# Access Compliance Report

### (Curb Ramps)

| Intersection ID: 54222 | Main Street: MIDWAY_PARK_DR | Cross Street: SOUTH_REA_PARK_LN | Location: SE           |
| ADA ID: E22A133AB169   | Ramp Type: Directional1     | Initial Pass/Fail: Fail         | Overall Compliance: No |

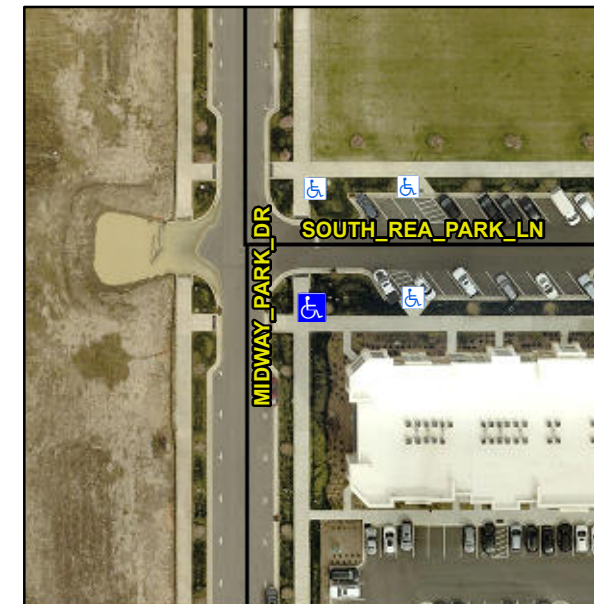
**R304.2.2**

| Compliance | Description           | Data | Compliance | Description                 | Data |
|------------|-----------------------|------|------------|-----------------------------|------|
| No         | Ramp Slope (%)        | 8.4  | N/A        | Grade Break XSlope (%)      | 0.0  |

**Remove & Replace Entire Ramp.**
